DEVELOPMENT REVIEW BOARD REPORT

PROJECT NAME/
CASE NUMBER **104th and Bell MEDCP
1-MP-2004**

REQUEST Request approval of the Master
 Environmental Design Concept Plan
 (MEDCP)

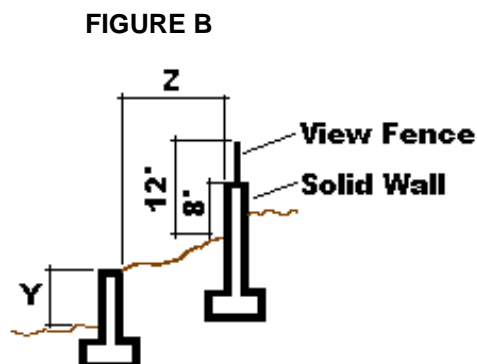
9. With the preliminary plat and/or Development Review application the developer shall provide details all of neighborhoods parks.
10. Unless otherwise approved by the Development Review Board through the preliminary process, any retaining wall and fence wall combination (a fence wall on top of a retaining wall) adjacent to streets, washes, open space, parks, vista corridors, scenic corridors shall not have a visual height greater the 8-feet. Walls combination that have a visual height greater than 8-feet, shall be stepped or broken up through the use of multiple retaining wall as shown Figure A.

The height of any individual retaining wall, within the stepped wall combination, shall not exceed a maximum of 6-feet, "x" dimension shown on Figure A. The separation between step walls, "w" dimension shown on Figure A, shall be a minimum of 4-feet when the lower retaining wall "x" has a visual height up to 4-feet. The minimum separation, "w" dimension shown on Figure A, shall be equal to the height of the "x" dimension when the visual height of "x" is greater than 4-feet.
